ADDENDUM NO. 2

DATE: December 4, 2020
FROM: Village of Villa Park Public Works Department
TO: All Plan Holders
PROJECT: **Harvard Avenue Improvements (Jefferson Park to Plymouth Street)**

TITLE:
**HARVARD AVENUE IMPROVEMENTS
JEFFERSON PARK TO PLYMOUTH ST.
TYPICAL SECTIONS**

PROJ. NO. 140092.00019
DATE: 12/1/2020
SHEET 4 OF 22
DRAWING NO.
TYP-1

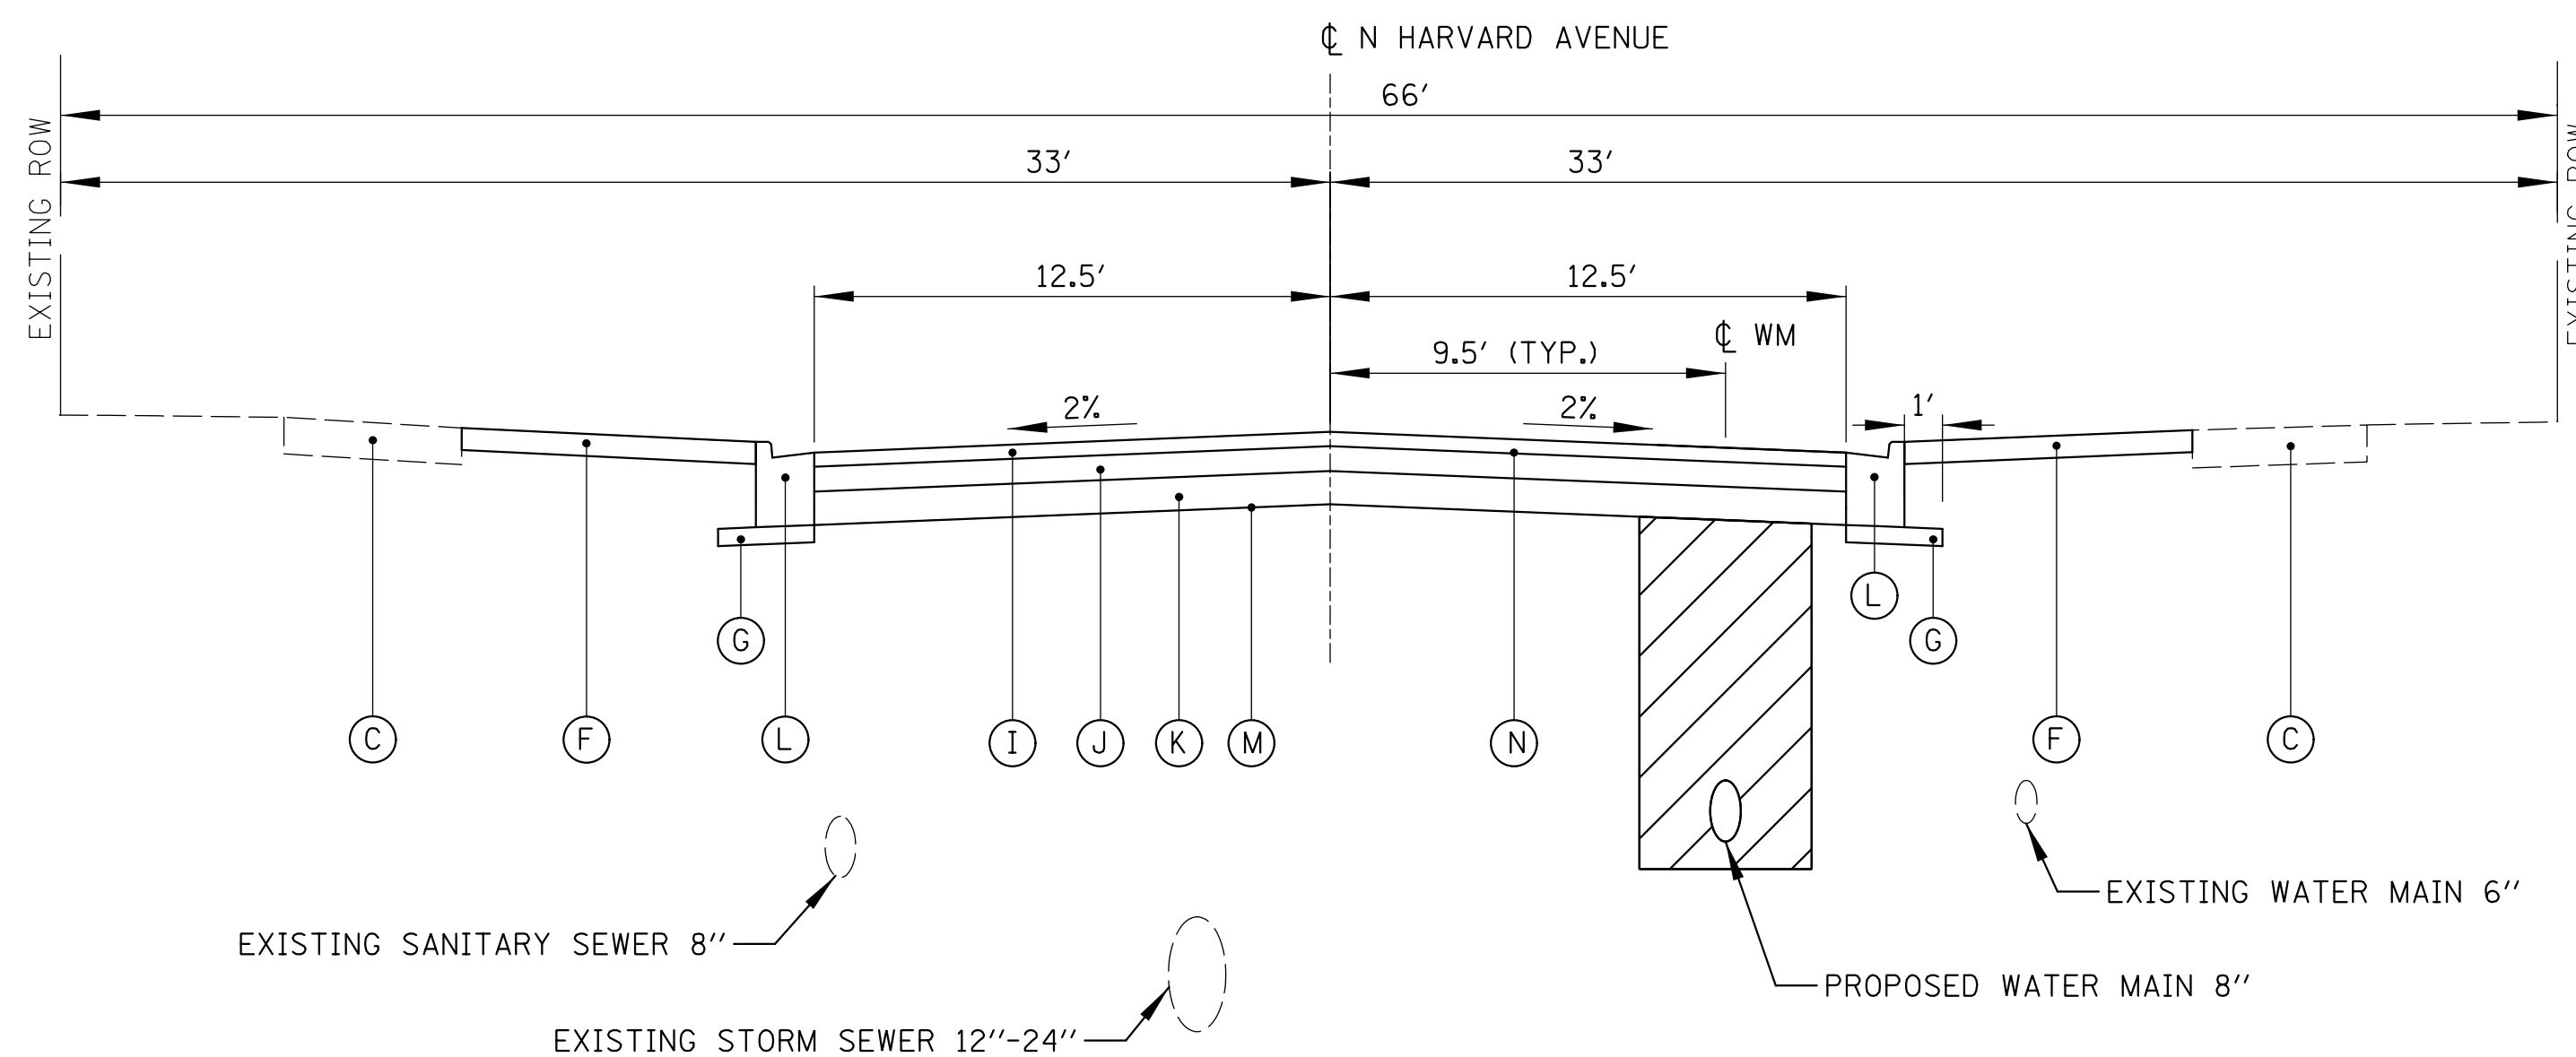
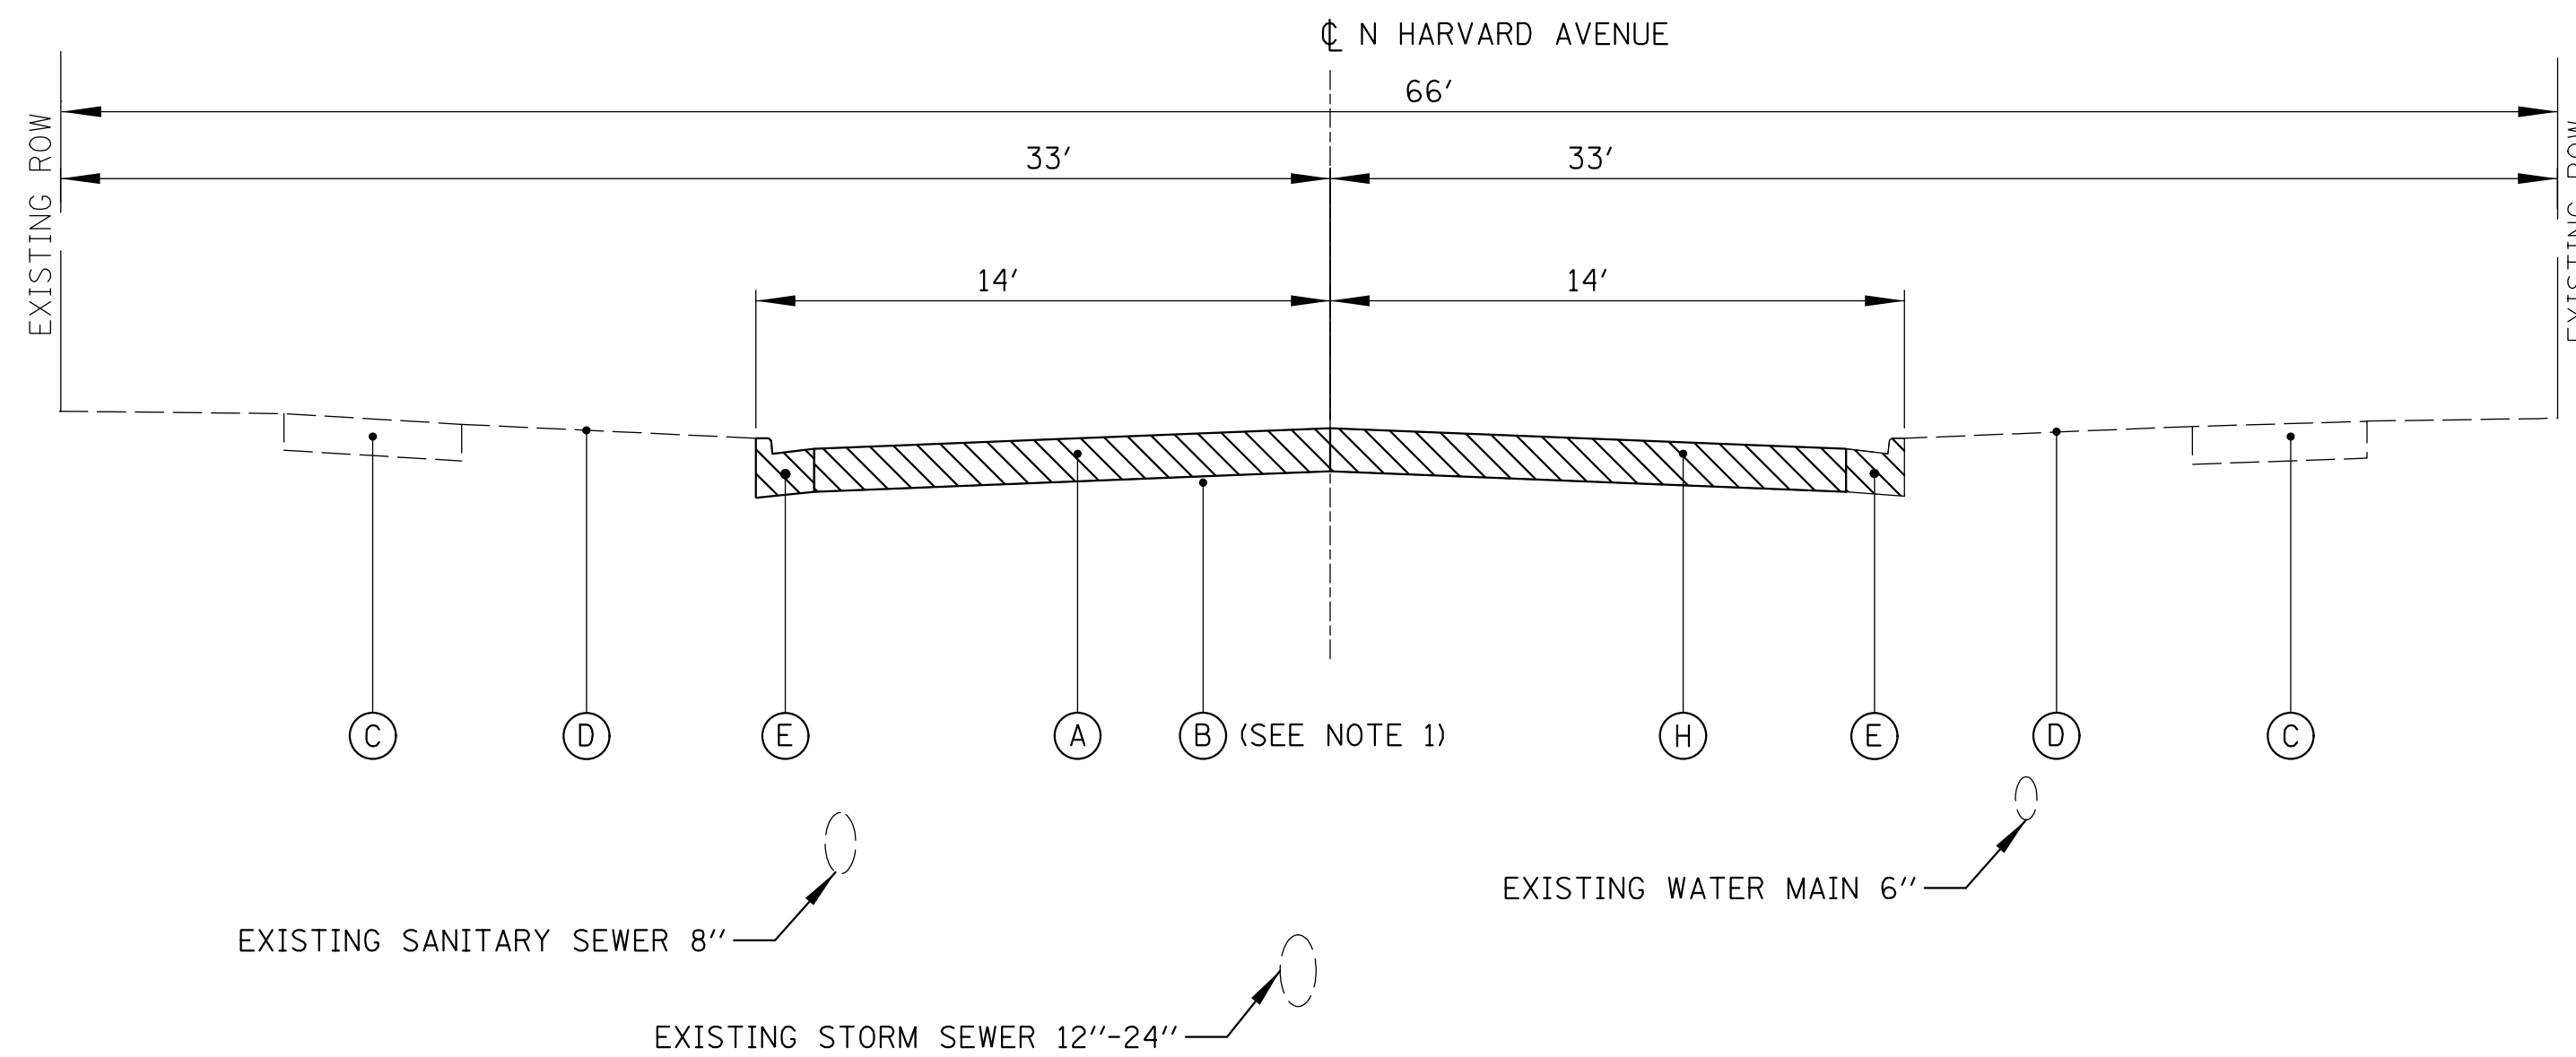
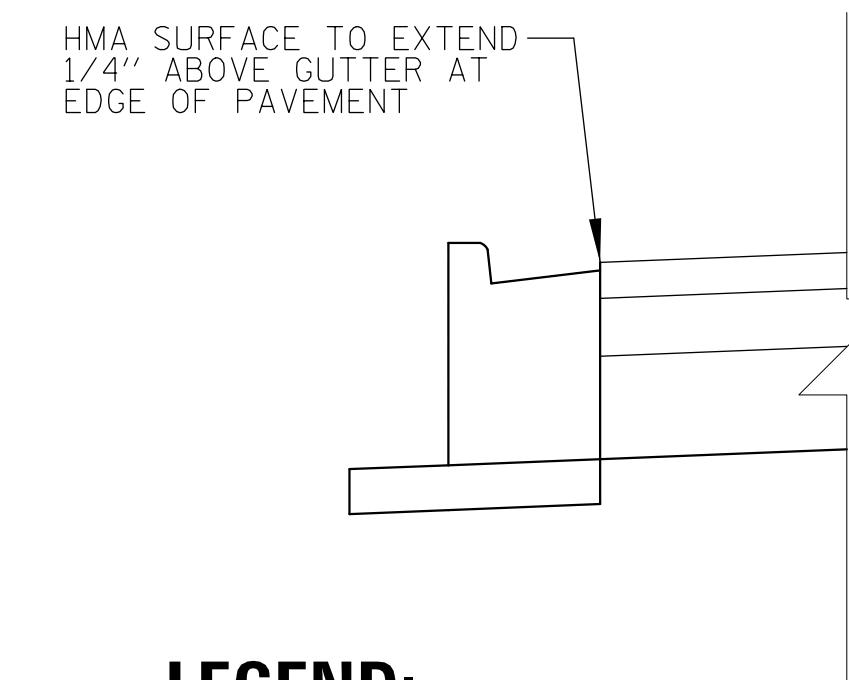
Replace sheet TYP-1 (sheet 4) with the attachment included with this addendum. A revision has been made to the Hot-Mix Asphalt Mixture Design Requirements table. HMA Binder Course for Class D Patches shall be N50 mix in accordance with the special provision for Class D Patches.
